RHODE ISLAND CONTRACT No. 2017-CB-053

Rehabilitation of Silver Creek Bridge No. 153

NOTICE TO PROSPECTIVE BIDDERS

ADDENDUM NO. 2 Prospective bidders and all concerned are hereby notified of the following changes in the Plans, Specifications, Proposal and Distribution of Quantities for this contract. These changes shall be incorporated in the Plans, Specifications, Proposal and Distribution of Quantities, and shall become an integral part of the Contract Documents.

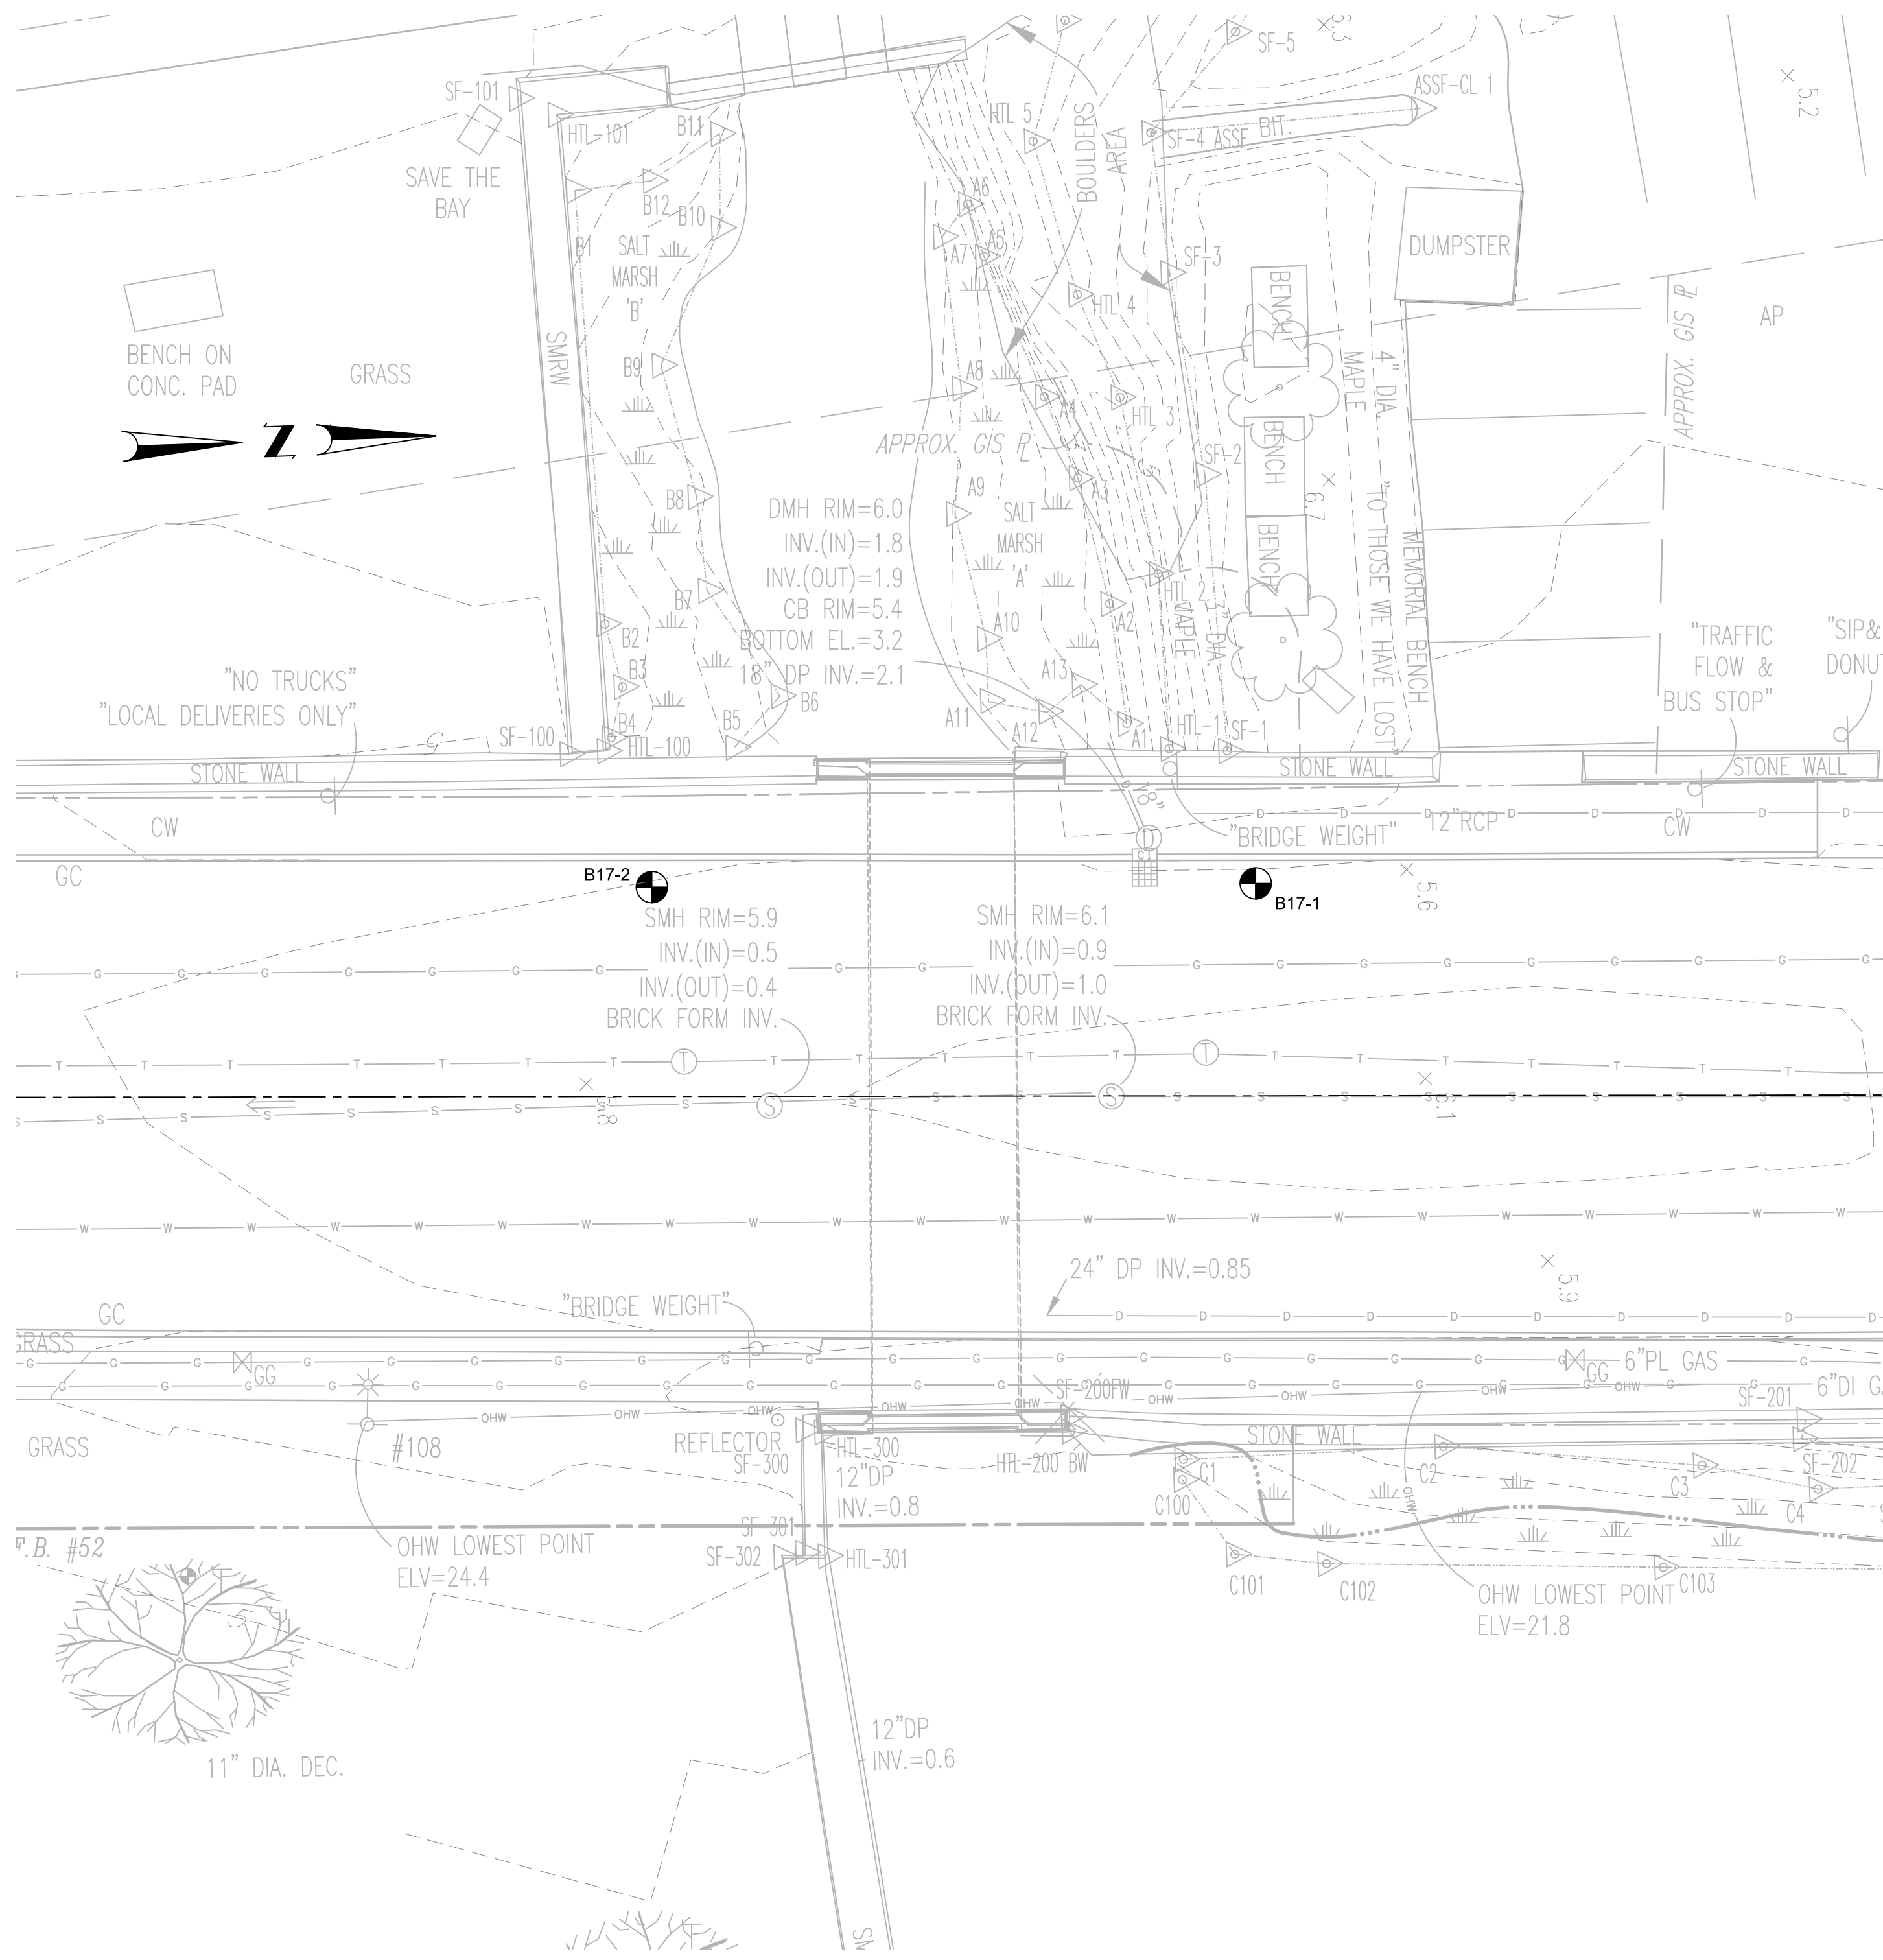
8. Replace Plan Sheet 24 with Sheet 24(R-1) attached to this Addendum #2. The estimated pile tip elevation have been revised.
9. Replace Plan Sheet 25 with sheet 25(R-1) attached to this Addendum #2. The gas main casing has been revised to 10" diameter, and the Elevation and Section Thru Abutment have been revised to indicate cast-in-place pile caps.
10. Replace Plan Sheet 39 with Sheet 39(R-1) attached to this Addendum #2. A detail has been added to show the limits of removal of the existing abutments to place the casings for the sewer and water mains.
11. Replace Plan Sheet 40 with Sheet 40(R-1) attached to this Addendum #2. The groundwater elevations on the boring logs have been revised.

The boring logs on Plan Sheet 40 suggest that groundwater was encountered at ground surface / elevation 6.4 (Boring Number B17-1) and at 2 feet above ground surface /elevation 8.4 (Boring B17-2). There is also a third parameter (3.5 feet @B1 and 4 feet @B2) that is not defined as to what this parameter refers to. The "normal" water elevation in the adjacent pond is noted at approximately elevation 1.8 (which is reasonably close to Bristol mean high water when converted to NAVD88), the (assumed MLW) water elevation in Bristol harbor is mapped at approximately -1.5 (which is also reasonable close to the Bristol MLLW elevation, when converted to NAVD88). Please confirm that Groundwater elevations on the boring logs are correct and identify the significance of the third groundwater parameter (3.5 feet @B17-1 and 4 feet @B17-2)." ----- "There appears to be a discrepancy between ground surface elevations provided on Plan Sheet 40. The ground surface elevations on the boring logs on Plan Sheet 40 are noted as El. 6.4. The topographic information on the exploration location plan suggests ground surface elevations of between 5.6 and 5.1 for Borings B17-1 and B17-2, respectively. Please confirm the datum to which the elevations are referenced on the boring logs, and confirm that the topographical information on the boring location plan is referenced to NAVD88.
